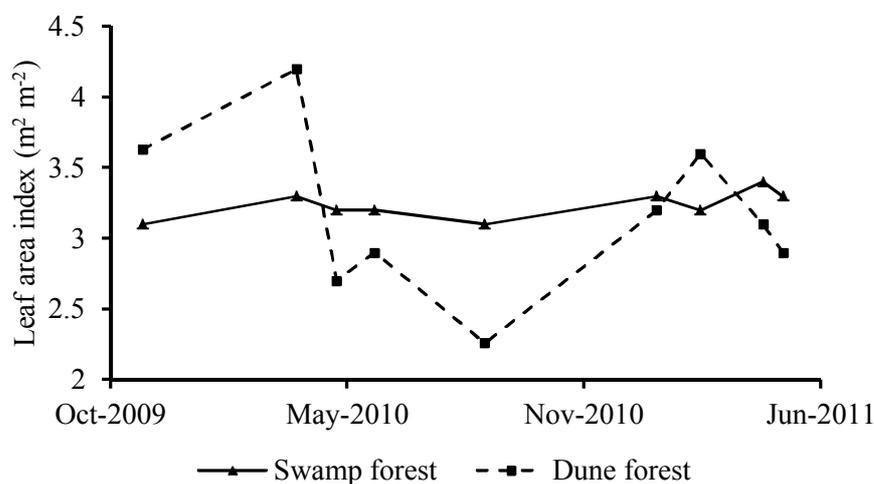
**Page 1731, line 26: It is possible to include a Table or figure of LAI fluctuations for the two sites?**

Graph of LAI included:

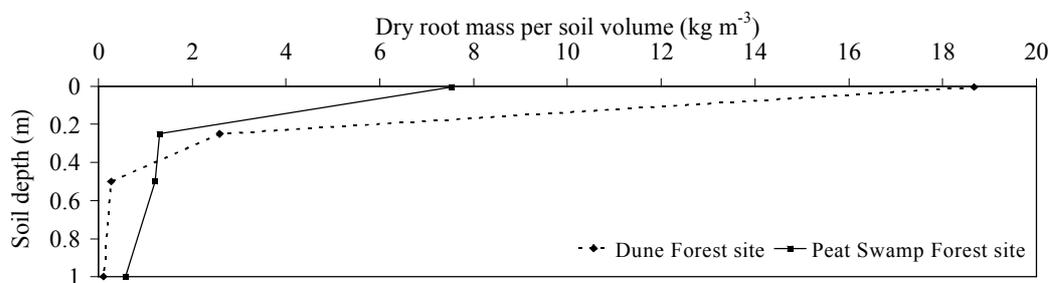
**Page 1734, line 15: Add:.....”below any branches.”**

Corrected.
